Land Development Regulations
Major Development Application
Major Development
Submittal Review Comments No. 3

Permit No.: **PZ23-0008**

Project Name: **SUBMITTAL NO. 3 REVIEW
PROPOSED COMMERCIAL DEVELOPMENT
METAL ROLL FORMING COMMERCIAL FACILITY
25870-000-000: 909 WEST STREET, PARKER, FLORIDA 32404
25869-000-000: 4623 EAST 2ND STREET, PARKER, FLORIDA 32404
25838-000-000: 4610 EAST HIGHWAY 98 BUSINESS**

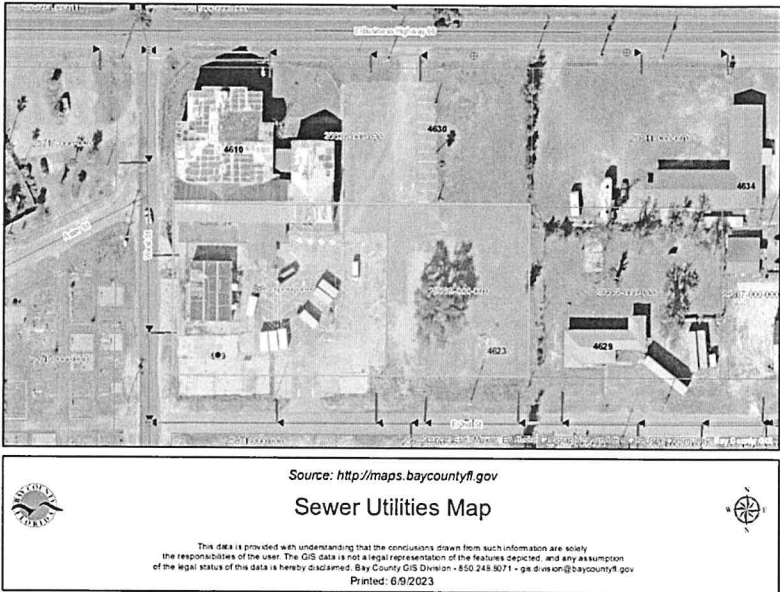
<p>The number calculated from the Data Table provided on the Site Data table differs from what Applicant has provided as the total. Applicant indicated that total impervious structures is 44,000 SF. Whereas, the total impervious when calculated from the Site Data Table is 50,696 SF. Please recalculate and revise Site Data table accordingly.</p> <p>In addition, lot coverage includes all impervious surfaces, which includes <u>stormwater ponds</u>. As indicated in the drainage report and Site Plan, there appears to be two ponds on site. Please add areas for all ponds to Site Data Table and recalculate the Lot Coverage using the correct, total impervious structures area.</p> <p>Once resubmitted, Lot Coverage will be confirmed if calculations are correct.</p> <p><i>As stated above, accurate dimensions and/or areas of the impervious structures (buildings, driveway, etc.) are requested to ensure that the City has the most up-to-date records for all structures located on these parcels and to assist in the review of lot coverage and additional development orders submitted for the same development in the future.</i></p>	Impervious Surface	Size in SF	Building	28,000	Pavement/Parking	12,787	Sidewalks	1,128	Heavy-Duty Asphalt	7,297	Gravel	1,484	Stormwater Ponds	???	Total	50,696
Impervious Surface	Size in SF																
Building	28,000																
Pavement/Parking	12,787																
Sidewalks	1,128																
Heavy-Duty Asphalt	7,297																
Gravel	1,484																
Stormwater Ponds	???																
Total	50,696																
15. Minimum Lot Size (≥7,500)	<p>APPROVED 8/15/2023: As referenced in Article 4-5.4.3.d – General Commercial – Minimum Lot Size is indicated as 5,000 square feet.</p> <p>The lot size is indicated as over 5,000 square feet in Comment No. 4 above which meets the requirement of greater than 5,000 square feet detailed in the LDR.</p>																
16. Floor Area Ratio (FAR)	<p>APPROVED 11/10/23:</p> <p>CITY COMMENT 8/15/23: As referenced in Article 4-5.4.3.e – General Commercial – Floor Area Ratio (FAR) is indicated as 1.5</p> <p>CITY COMMENT 11/10/23: A revised Site Plan was submitted on 10/30/23 indicating new lot area that was used to recalculate the FAR as follows. FAR Calculation: Building Area/Lot Area = 28,000/125,017 = 0.22 FAR</p>																
17. Impervious Surface Ratio (ISR)	<p>RESUBMIT 8/15/23: CITY COMMENT 8/15/23: As referenced in Article 4-5.4.3.f – General Commercial – Impervious Surface Ratio is indicated as 0.7</p> <p>ISR is calculated according to the lot area and impervious surfaces on the parcel.</p>

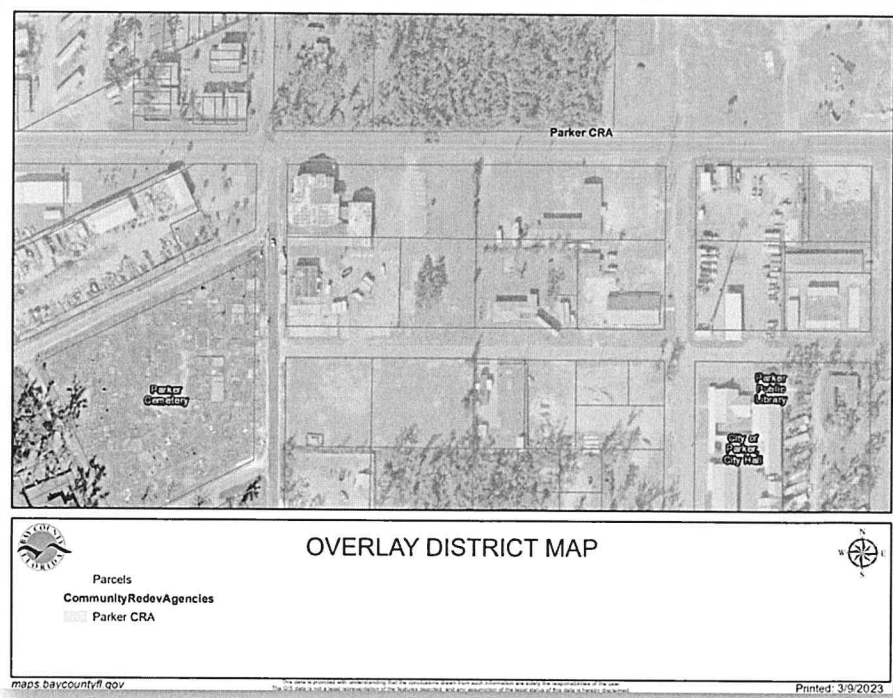
<p>The number calculated from the Data provided on the Site Data table differs from what Applicant has provided as the total. Applicant indicated that total impervious structures is 44,000 SF. Whereas, the total impervious when calculated from the Site Data Table is 50,696 SF. Please recalculate and revise Site Data table accordingly.</p> <p>ISR does <u>not</u> include stormwater ponds.</p> <p>ISR = Total Impervious (minus SW Ponds)/Total Lot Area</p> <p>ISR = 50,696 SF/125,017 SF = 0.41</p> <p>Applicant indicated an ISR of 0.35 which is assumed to be because of the total impervious area discrepancy stated above. Please recalculate and revise the ISR using 50,696 SF of impervious structures.</p>	Impervious Surface	Size in SF	Building	28,000	Pavement/Parking	12,787	Sidewalks	1,128	Heavy-Duty Asphalt	7,297	Gravel	1,484	Total	50,696
Impervious Surface	Size in SF														
Building	28,000														
Pavement/Parking	12,787														
Sidewalks	1,128														
Heavy-Duty Asphalt	7,297														
Gravel	1,484														
Total	50,696														
<p>18. Distance between Buildings</p>	<p>N/A: As referenced in Article 4-5.9 – Distance Between Buildings, Applicant shall provide:</p> <ol style="list-style-type: none"> 1. The minimum distance between adjacent stand-alone buildings shall be a total of 10 feet. 2. Distance shall be measured at the narrowest space between structures, whether a main living unit, principal structure, allowable attachment, or an accessory use, and shall not include roof overhang (eave).
